Access Compliance Report

Public Rights-of-Way

(Pedestrian Signals)

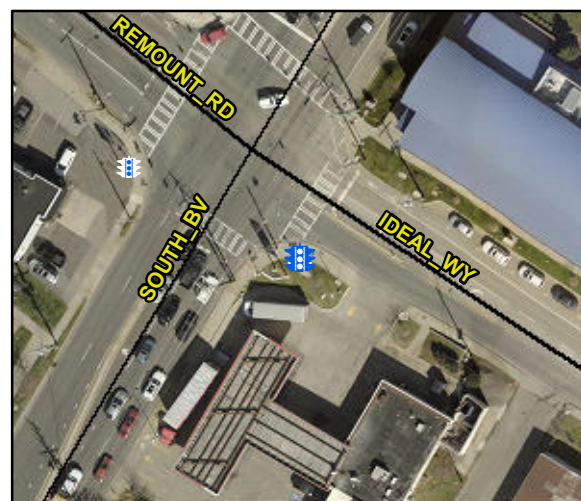
Intersection ID: N/A	Main Street:	Cross Street: N/A	Location: N/A
ADA ID: 4FC99A3ED625	Signal Type: One Push Button-APS	Overall Compliance: No	Severity Score: BTN 1: N/A BTN 2: N/A No BTN: N/A
Codes/Mitigation Info/Possible Solution		Field Measurements/Component Compliance

PROW/ADA: R410.6, TMUTCD 4e.08, R404.3, R404.2, R209.1, MUTCD 4e.10

Possible Solutions: Replace Signal Push Button With APS Button on New Post. Remove & Replace Sign.
